ADDENDUM TO CONTRACT DOCUMENTS NUMBER 3

Contract: CONTRACT CRO-334G – STRUCTURES AND EQUIPMENT
CONTRACT CRO-334E – ELECTRICAL

Description: NEW CROTON AQUEDUCT REHABILITATION

May 2008

CONSOLIDATION GROUTING OF PRESSURIZED AQUEDUCT
PLAN AND PROFILE - SHEET 1 OF 4

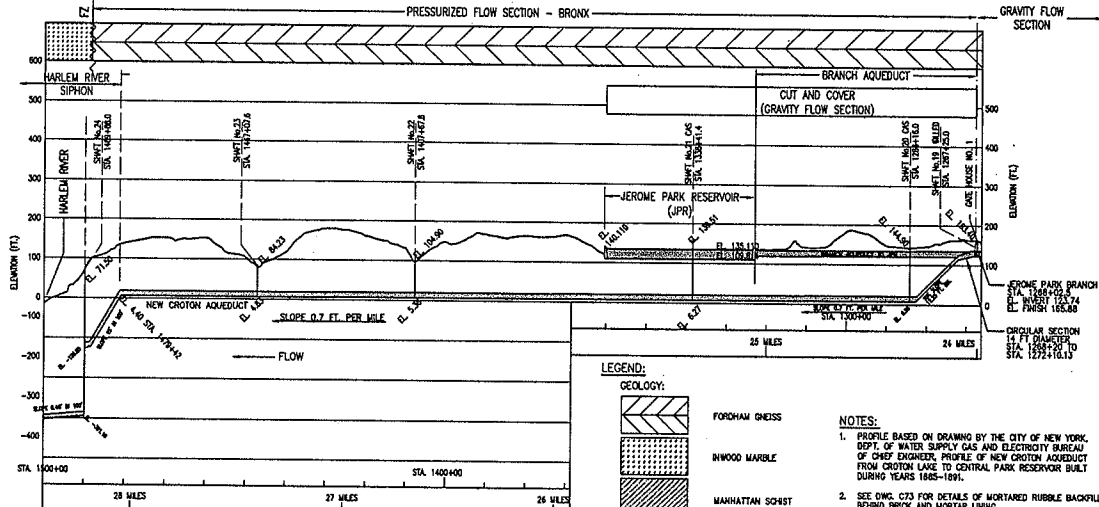
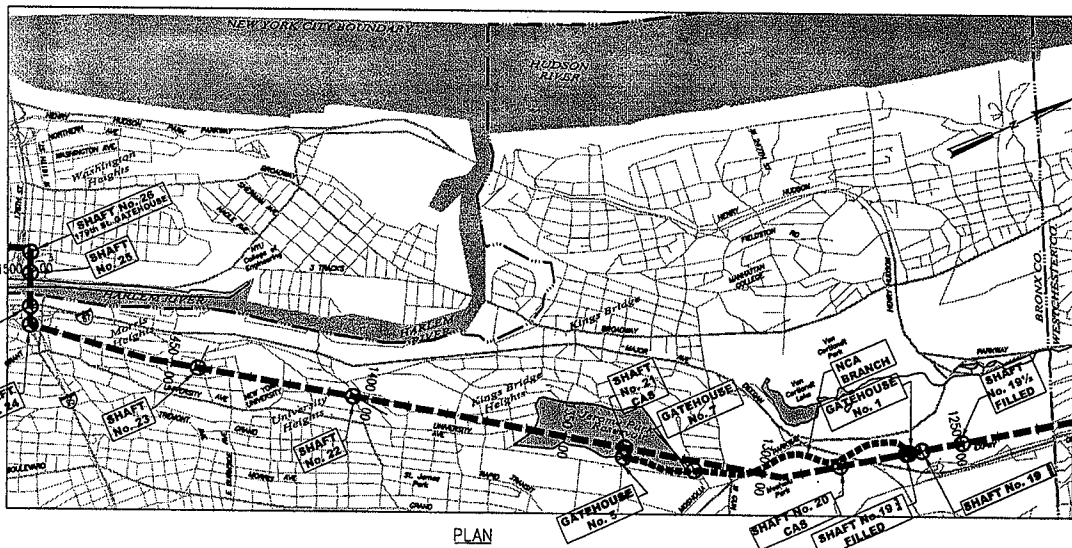
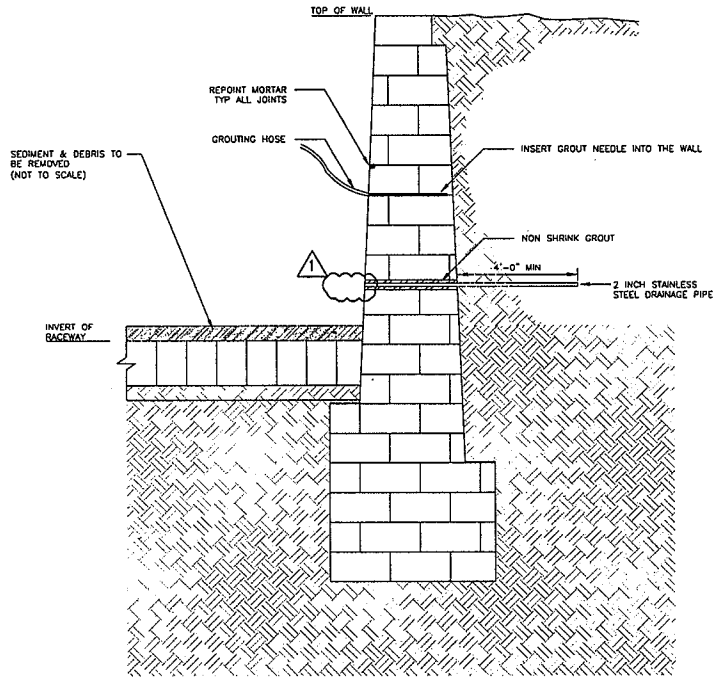
WORK LOCATION	GROUT METHOD	MINIMUM TUNNEL LENGTH COVERED BY GROUT	CO POSITIONS TO MINIMIZE INFILTRATION INTO TUNNEL	SECTION LENGTH OF CO	CO POSITIONS TO FILL VOIDS BEHIND LINING/BACKING MATERIAL	
					CO POSITION	CO POSITION
1267+70	CC			96	1267+23 - 43 (12:00 - 3:00)	1267+42 - 1268+16 (9:00 - 12:00)
1268+70	CCG	1269+00 - 1269+20	12:00 - 8:00	89	1268+00 - 1269+00 (9:00 - 3:00)	1268+14 - 62 (9:00 - 11:00), 65 - 68 (9:00 - 3:00)
1269+70	CC	1269+20 - 1270+05	FULL CRC	100	1269+11 - 18 (12:00 - 12:00), 25 - 26 (9:00 - 12:00), 43 - 60 (12:00 - 3:00), 65 - 1270+2 (9:30), 495 - 1270+4 (2:00 - 3:00)	
1270+70	CC			83	1270+25 - 75 (9:00 - 11:00), 76 - 86 (12:00 - 3:00), 87 - 95 (12:00 - 3:00), 97 - 98 (9:00), 99 - 100 (9:00)	
1271+70	CC			100	1271+20 - 30 (9:00 - 3:00), 40 - 46 (11:00 - 12:00), 55 - 70 (1:00 - 3:00), 71 - 75 (11:00 - 12:00), 1272+06 - 20 (9:00 - 2:00)	
1274+25	CCG	1274+00 - 1274+60	8:00 - 3:00	60	1280+34 - 39 (12:00), 485 - 500 (12:00)

CONTRACT CRO-334G-STRUCTURES & EQUIPMENT
 RACEWAY WALL REPAIRS

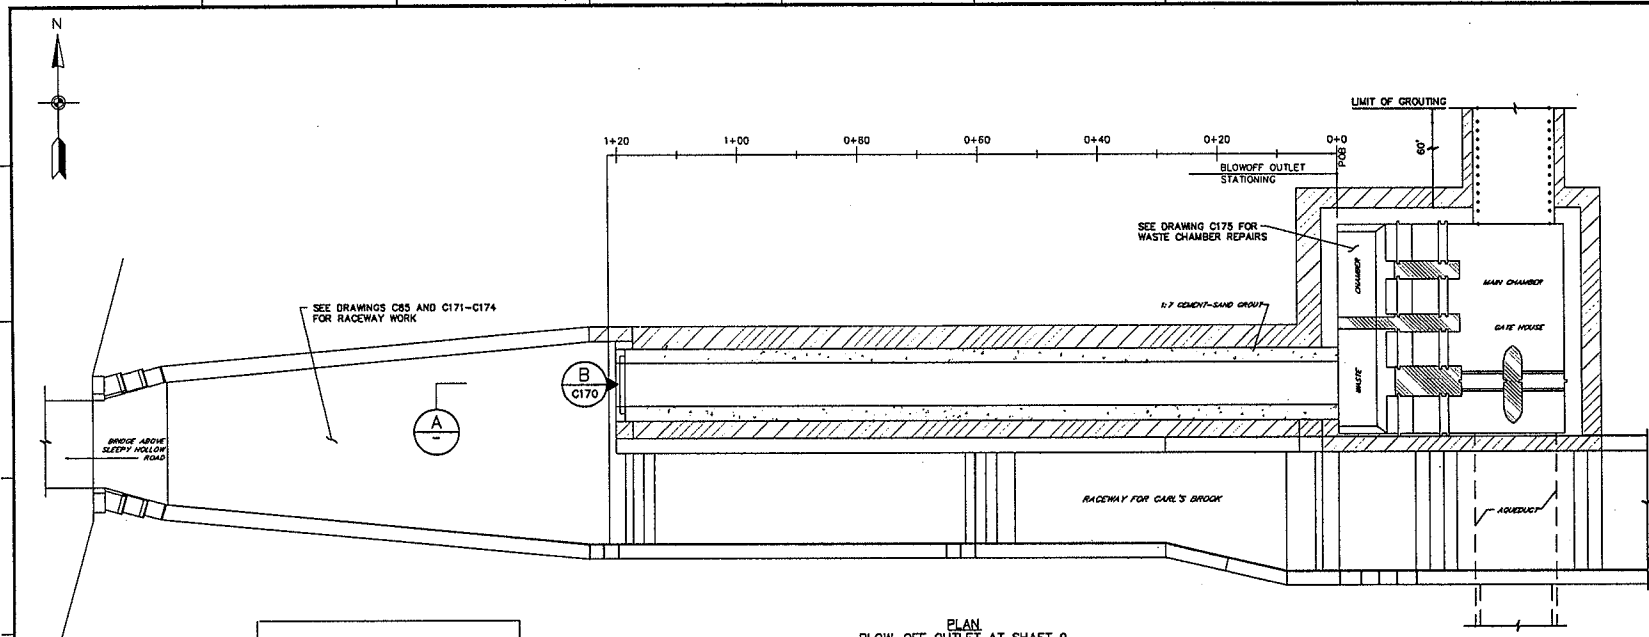
1. REMOVE THE TREE STUMPS AND VEGETATION ON THE WALL ACCORDING TO THE NOTES ON DRAWINGS C116 AND C125.
2. REMOVE LOOSE AND DETERIORATED MORTAR, MORTAR NOT BONDED TO ONE SIDE OF A UNIT, OR EASILY DEBONDED FROM ONE SIDE OF A UNIT SHALL BE REMOVED. THE WORK TO REMOVE MORTAR SHALL PROCEED FROM ONE SIDE TO THE OTHER HORIZONTALLY AND FROM TOP TO THE BOTTOM VERTICALLY. THE MAXIMUM LENGTH OF AN OPEN JOINT SHALL BE 6' OR AS ALLOWED BY THE ENGINEER.

7. ONE DAY AFTER GROUTING, REMOVE TEMPORARY PLUGS AND POINT HOLES WITH NON-SHRINK MORTAR. TOOL THE MORTAR TO MATCH THE ADJACENT EXISTING. REMOVE AND DISPOSE OF ALL SPILLED MORTAR AND GROUT.

REHABILITATION OF BLOW-OFF OUTLET AT
SHAFT NO. 9 - SHEET 1 OF 2

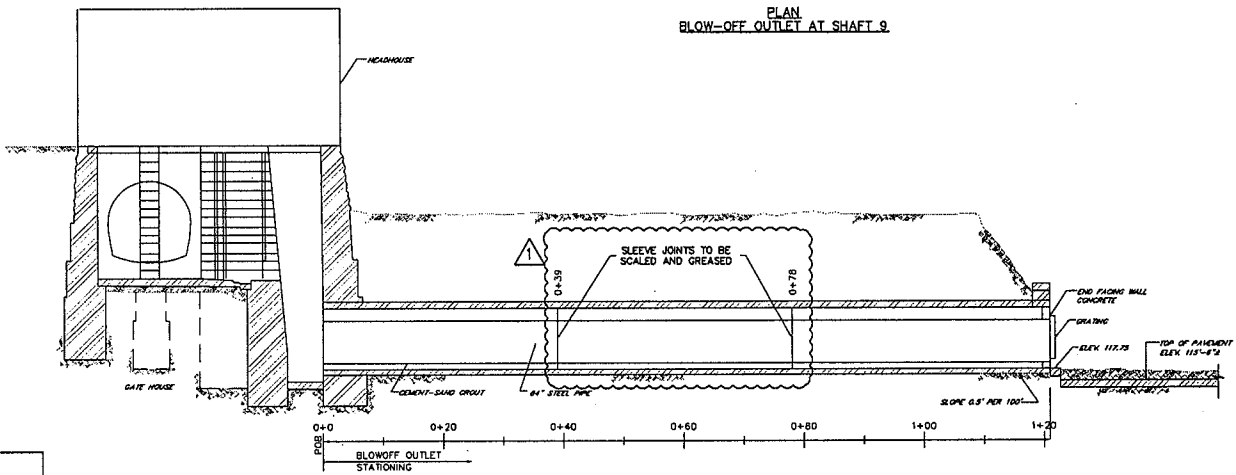
1. STATIONING BEGINS AT FACE OF WASTE CHAMBER WALL.
2. CLEAN BLOW-OFF IN CONJUNCTION WITH RACEWAY WORK.
3. REMOVE SEDIMENT FROM INVERT. REMOVE TUBERCLES, SCALE AND REMOVE LOOSE COATING FROM PIPE PERIMETER (600 SF OF SCALING).
4. GROUT AT 0+37 AND 0+85, FOR LEAKS AT 3 O'CLOCK (30 CF AND 10 HOLES PER LOCATION).
5. INJECT JOINTS WITH NSF APPROVED GREASE, SUITABLE FOR POTABLE WATER (70 LB TOTAL IN 2 JOINTS).

- DENOTES SURFACE TO BE GROUTED BEHIND AT LOW PRESSURE (5 PSI)
1. BRICK REPAIRS WERE MADE IN 2005. ASSIST ENGINEER IN INSPECTION OF TUNNEL SURFACES. REPOINT AND REPLACE BRICK AS DIRECTED.
 2. GROUT FROM BOTTOM TO TOP AND NORTH TO SOUTH AND IN ACCORDANCE WITH SPECIFICATIONS AND/OR AS DIRECTED BY ENGINEER.
 3. DO NOT EXCEED 5 PSI UNLESS DIRECTED BY ENGINEER.
 4. QUANTITY OF GROUT 100 CF.

CONTRACT CRO-334C-STRUCTURES & EQUIPMENT	DATE FEBRUARY 2008
REHABILITATION OF WASTE CHAMBER SHAFT NO. 9	SHEET 117 of 284
	DWG. NO. C175

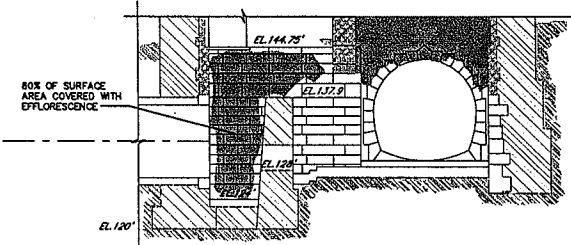
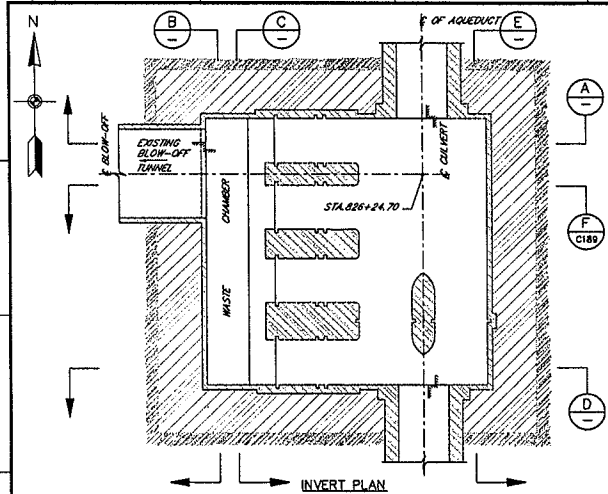
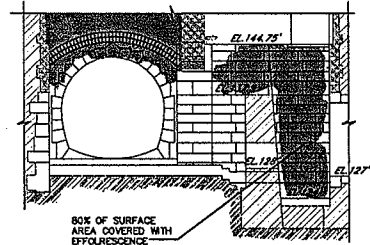
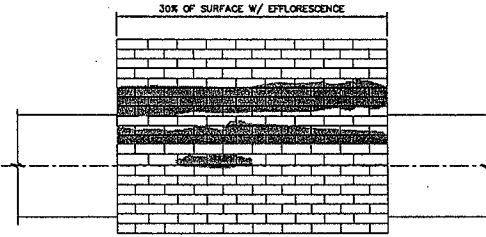
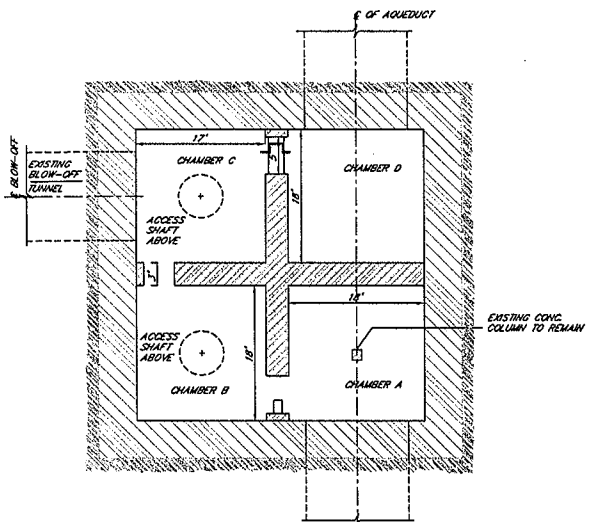
- REMOVE THE SEDIMENTS AND DEBRIS AT THE INVERT. SEDIMENTS ARE ASSUMED TO BE CONTAMINATED.
- CLEAN THE MASONRY WALLS, REMOVING ALL EFFLORESCENCE.
- PROVIDE ASSISTANCE FOR THE ENGINEER'S INSPECTION OF THE INVERT AND OF THE WASTE CHAMBER WALLS.
- IF AND AS DIRECTED BY THE ENGINEER, REPAIR OR REPLACE DAMAGED INVERT MASONRY UNITS AND REPORT.
- REMOVE ALL LOOSE AND BROKEN MORTAR FROM THE JOINTS IN THE MASONRY WALL, REPORT, LEAVING OPENINGS FOR GROUT AS NOTED ON CBS.
- INJECT GROUT AT LOW PRESSURE TO FILL IN BEDDING JOINT. SEE CBS FOR NOTES ON GROUTING AND PRESSURES.

REHABILITATION OF SHAFT NO. 14
 SHEET 1 OF 5

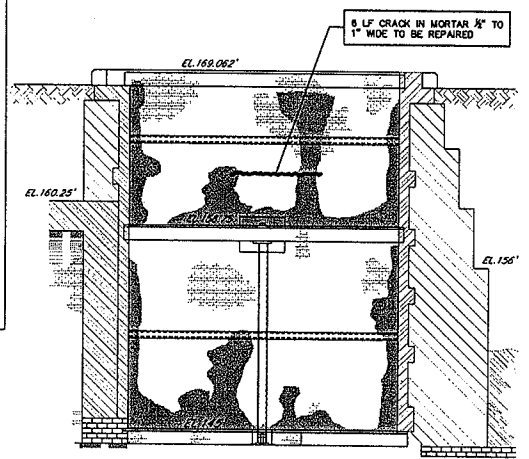
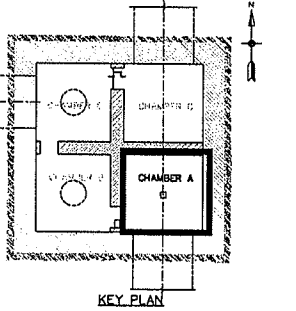
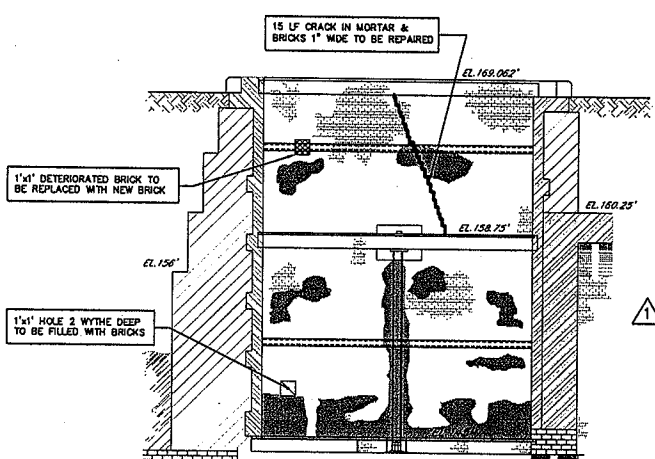
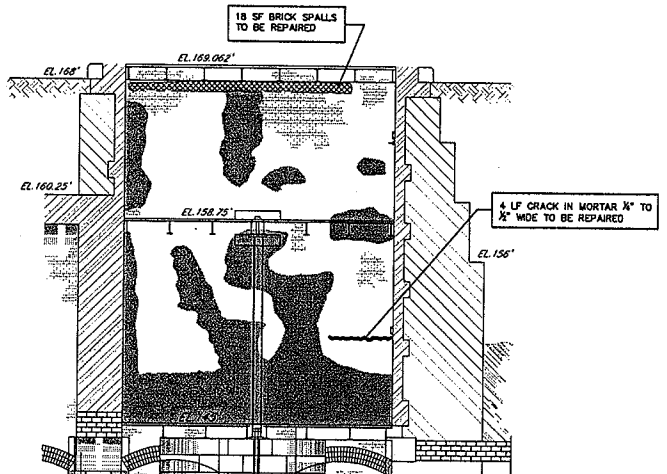
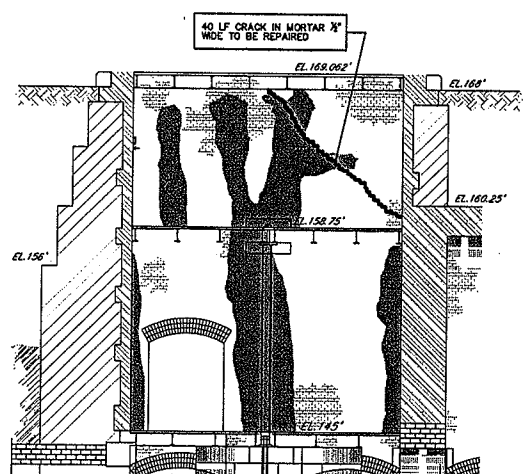
- KEY:**
- INDICATES EXISTING EFFLORESCENCE
 - INDICATES EXISTING SPALLS OR DETERIORATED BRICK
 - INDICATES EXISTING CRACKS $\frac{1}{8}$ " WIDE OR GREATER
- NOTES:**
1. BRICK SPALLS TO BE REPAIRED USING DETAILS FOR BRICK AND MORTAR LOSS REPAIR SEQUENCE.
 2. ALL EFFLORESCENCE IS TO BE REMOVED FROM THE INTERIOR BRICK SURFACE.
 3. ALL MORTAR JOINTS ON ALL INTERIOR BRICK SURFACES TO BE REPOINTED IN CONFORMANCE WITH SPECIFICATIONS.
 4. CRACKS $\frac{1}{8}$ " OR GREATER TO BE REPAIRED IN CONFORMANCE WITH DRAWINGS AND SPECIFICATIONS. REPOINT CRACKED JOINTS. REPLACE CRACKED BRICKS.

MORTAR	QUANTITY	UNIT
REPOINT	10,800	LF
REMOVE AND REPLACE MORTAR	85	LF
